BOARD ACTION REPORT – APPEALABLE ITEM

Project Name: 52 Modern

---STAFF REPORT---

ITEM: **52 Modern (2018-049)** - Class V Site Plan and Architectural Elevations and Landscape Plan to construct twelve townhomes.

SP-1

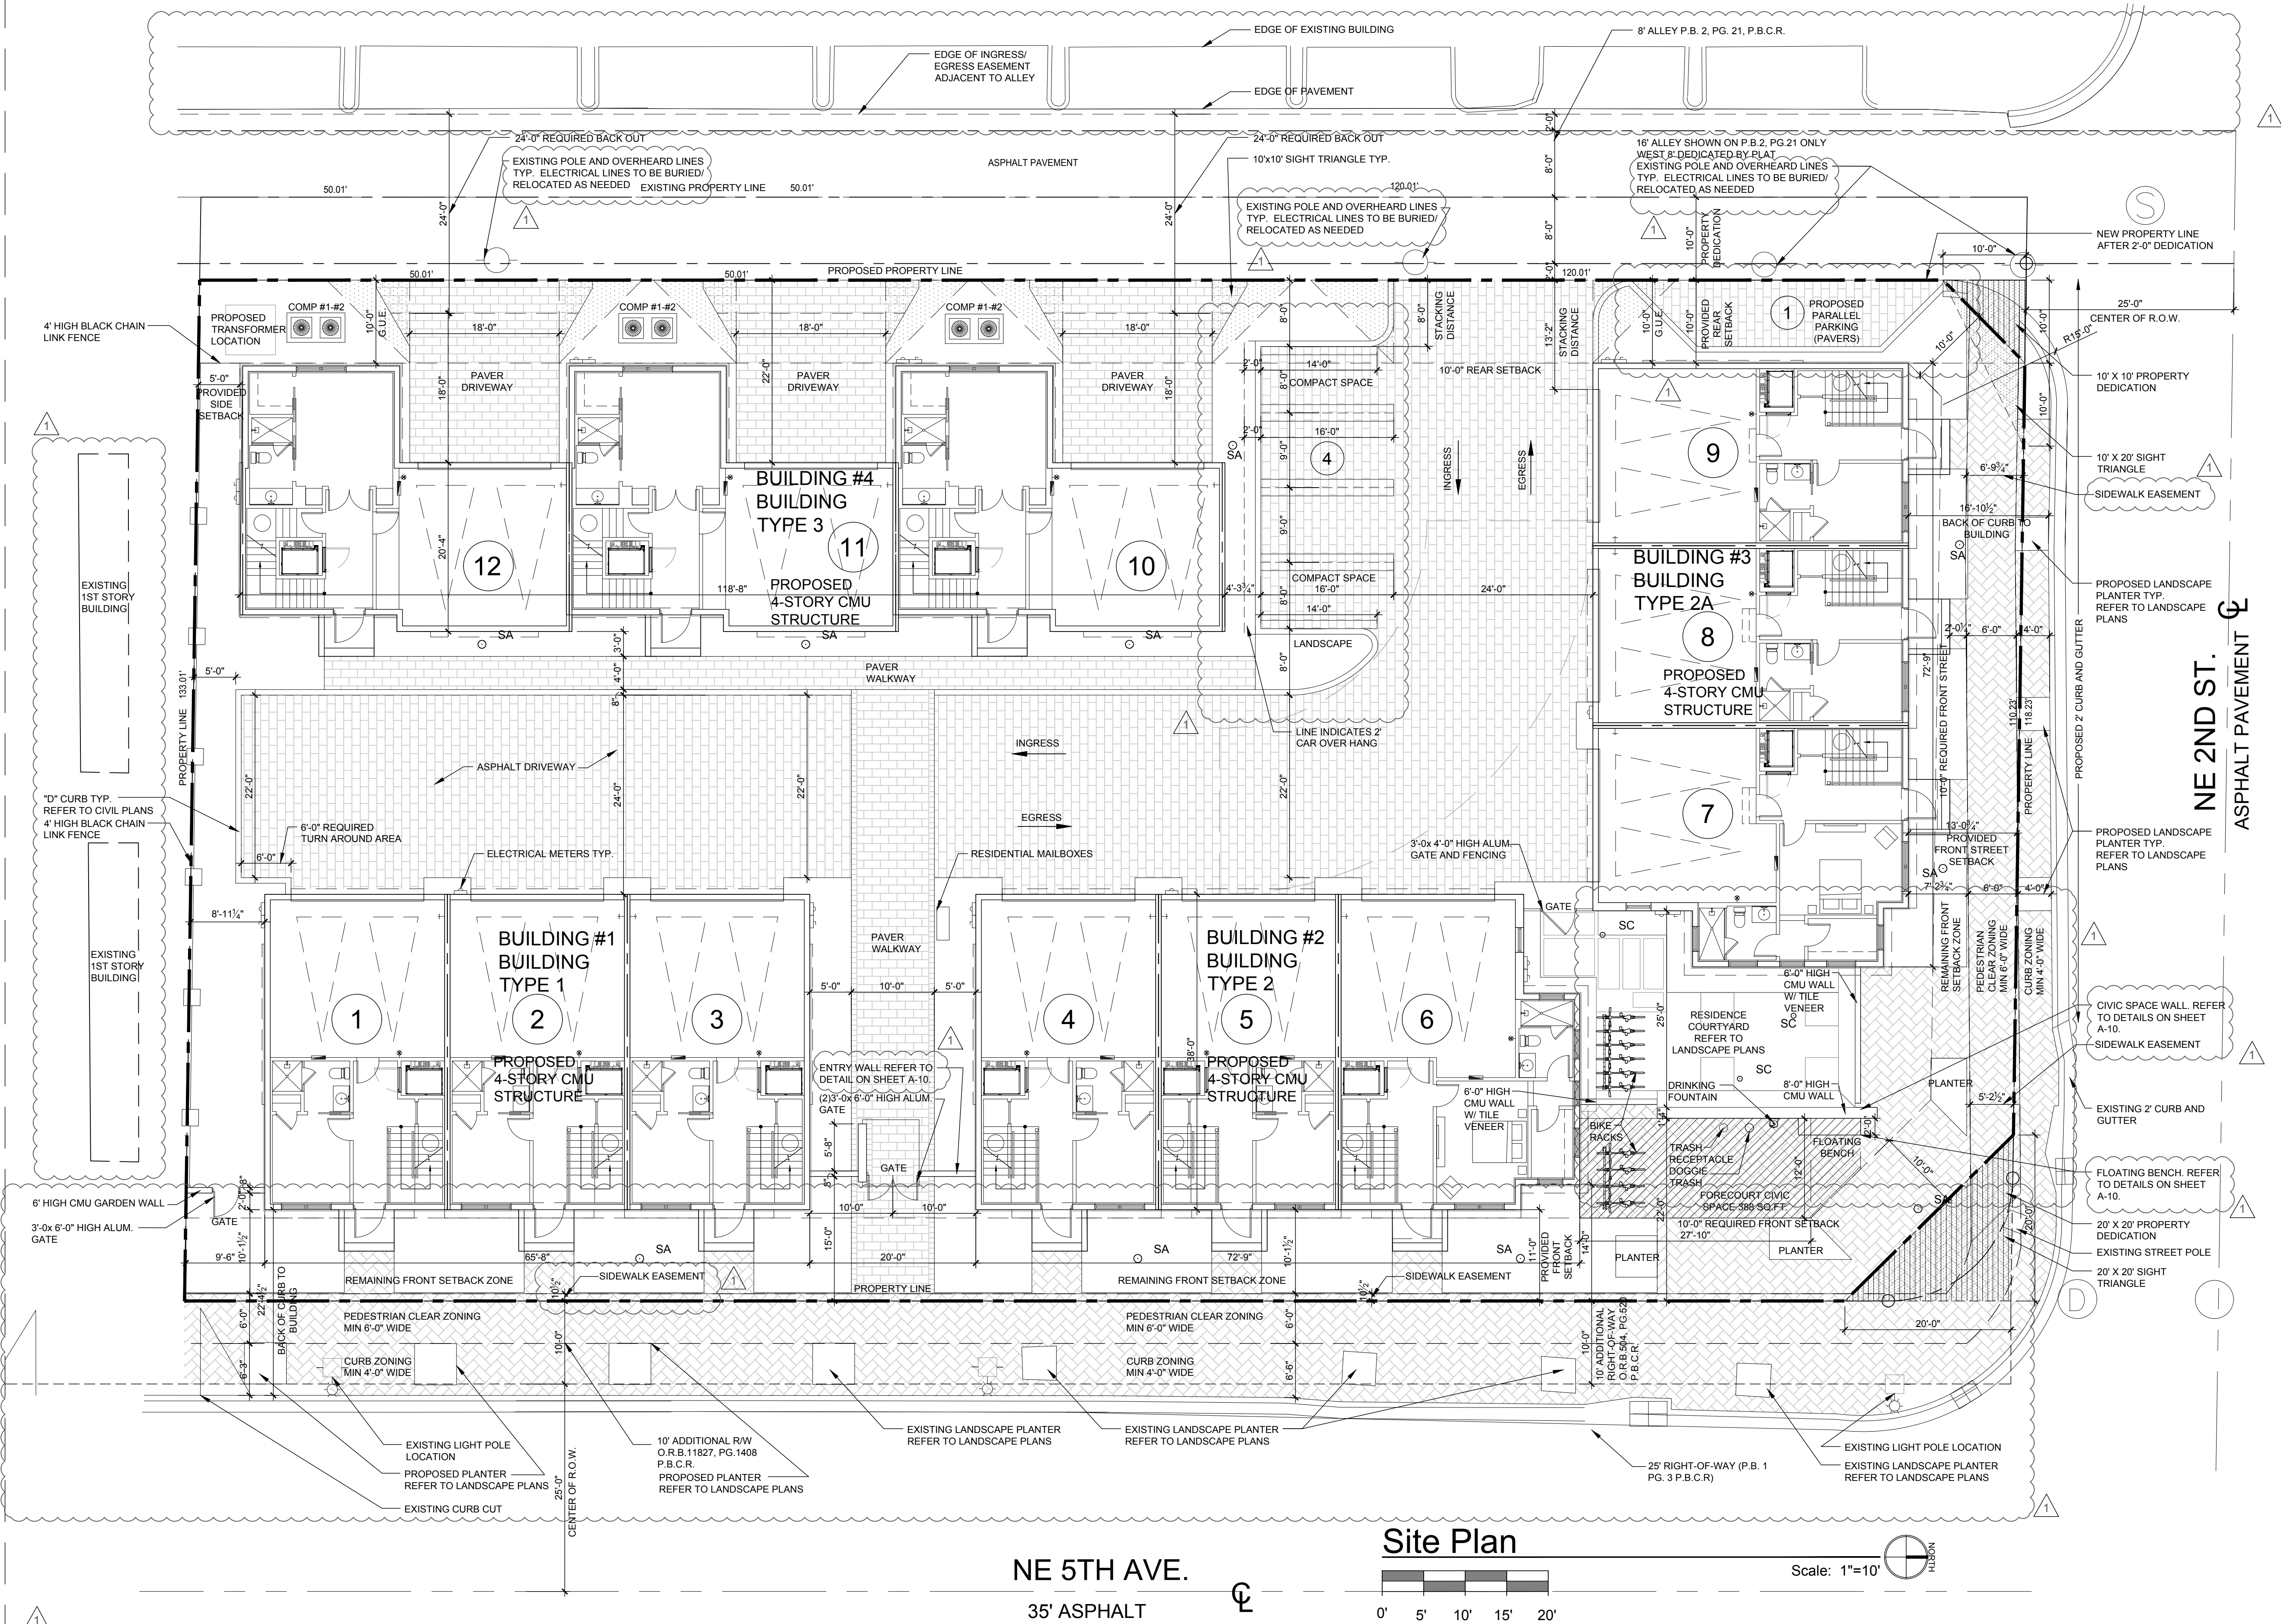
The proposed buildings comply with the dimensional requirements in Table 4.4.13(C). **Prior to site plan certification, the building frontage chart shall be revised, the guest parking calculation shall be revised, and the setback for the 4th floor shall be added to the setback chart and a dimension showing the 10 foot setback to the window overhang shall be added to the site plan.**

The trash and recycling must be screened from the public right of way. The applicant has indicated that the trash and recycling containers will be placed in the garage. **Prior to site plan certification, a note will be added to the plan stating the trash and recycling containers will be stored in the garage.**
